Response-to-the Departmental Comments

Proposed Temporary Public Vehicle Park (Excluding Container Vehicle) with Ancillary Office and Associated Filling of Land for a Period of 3 Years at Lot 385 S.B RP (Part) in DD 78 and Adjoining Government land, Tsuen Yuen Ha, Ta Kwu Ling North, New Territories (Application No. A/NE-TKLN/104)

**FIGURE 2.2A**

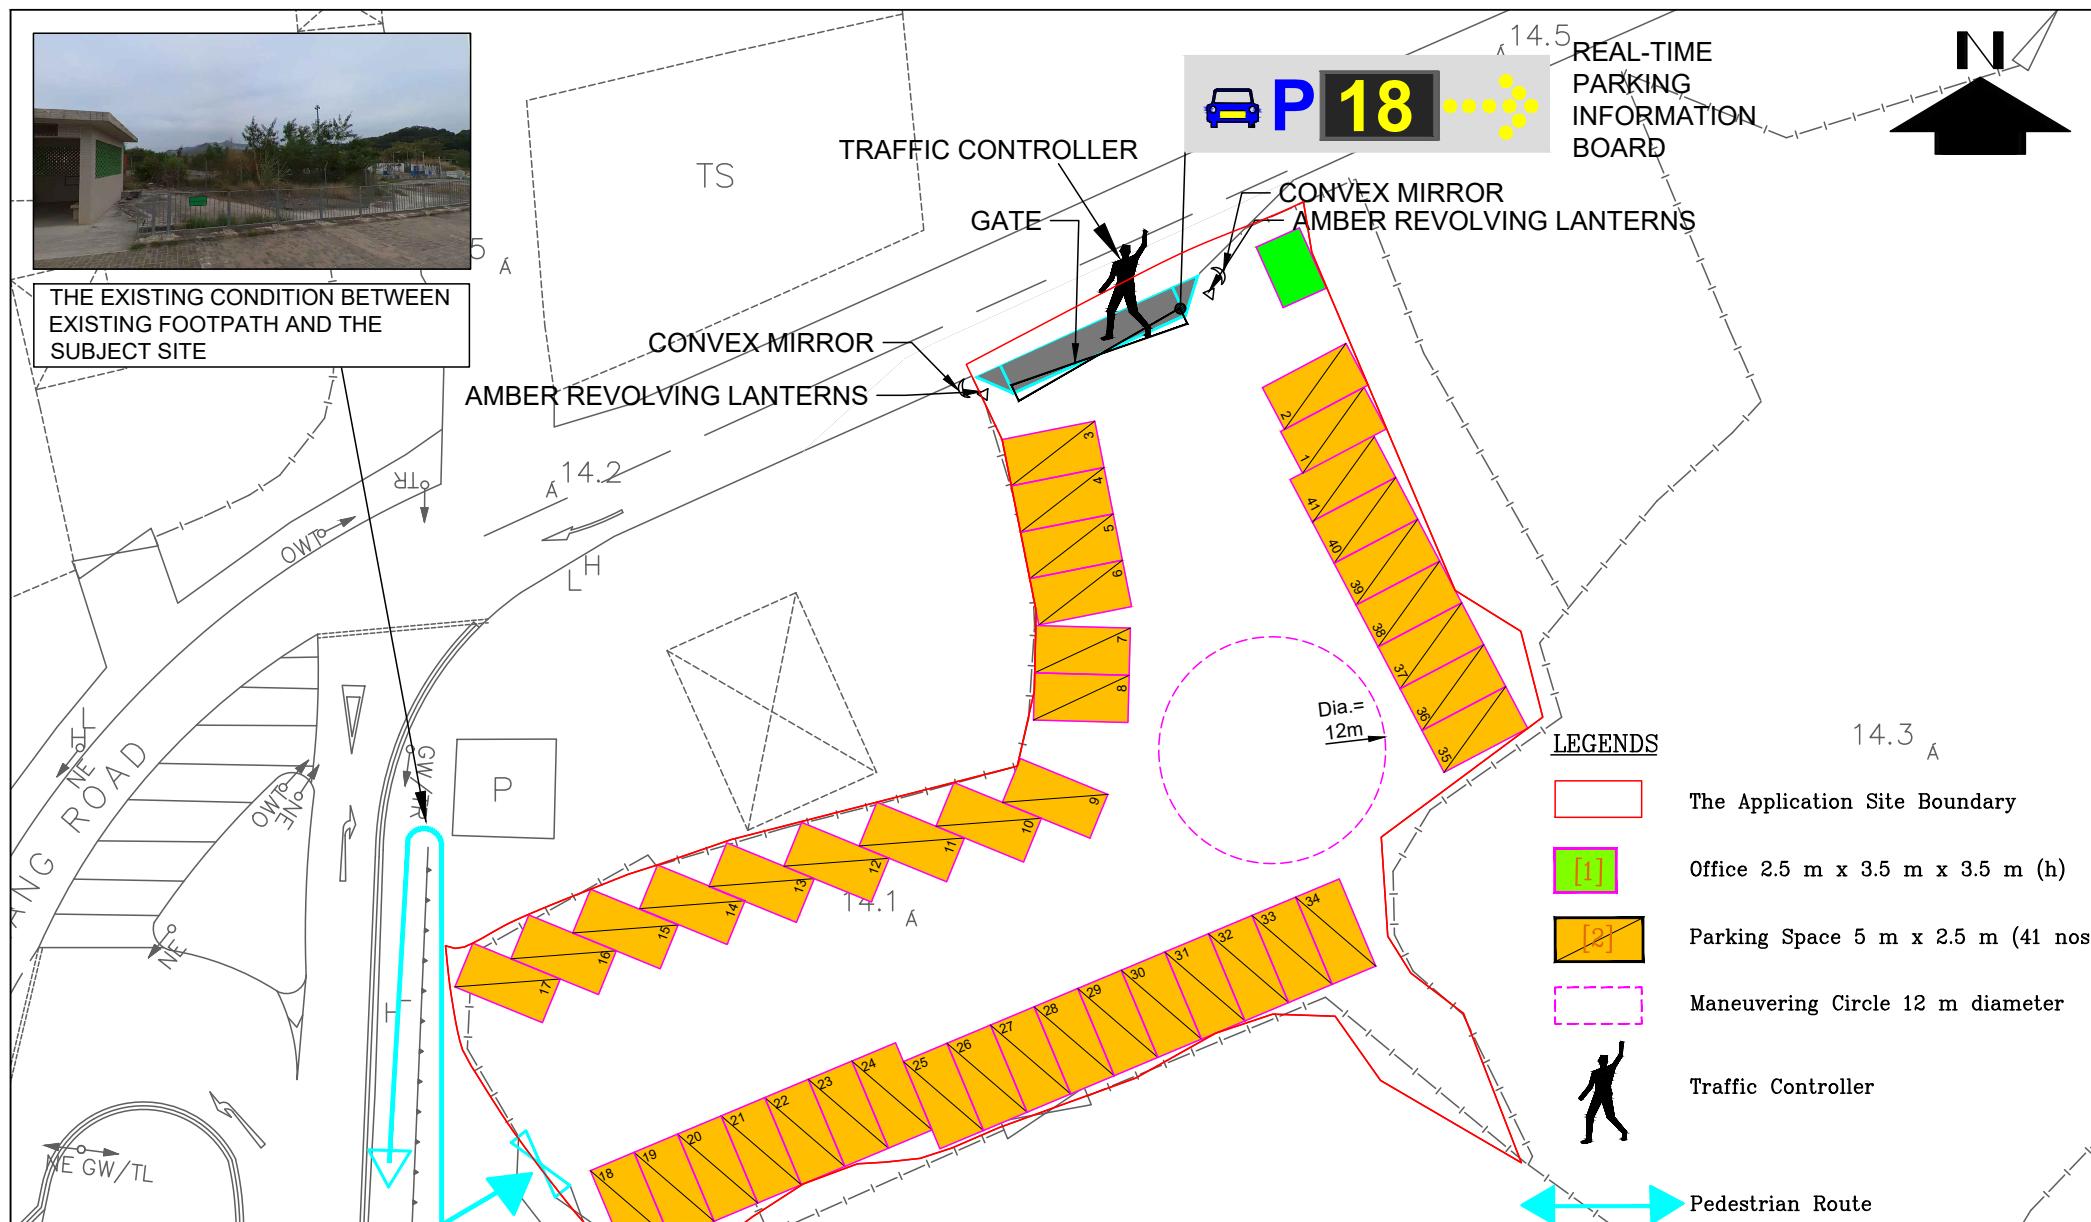
<p>is for the entire application site or the portion of “AGR” zone. Also, please supplement if further filling of land will be involved; and</p> <p>3. Please be advised that part of the application site boundary is missing from Figure 2.2A (Title: Safety Measures at the Proposed Vehicular Run-in/out) (Appendix I refers). Please rectify in accordance with the actual application site submitted by you previously.</p>	<p>entire application site. No further filling of land will be involved.</p> <p>3. Revised Figure 2.2A (Title: Safety Measures at the proposed Vehicular Run-in/out) is attached herewith in which the site boundaries had been rectified in accordance with the actual application site submitted.</p>
--	---
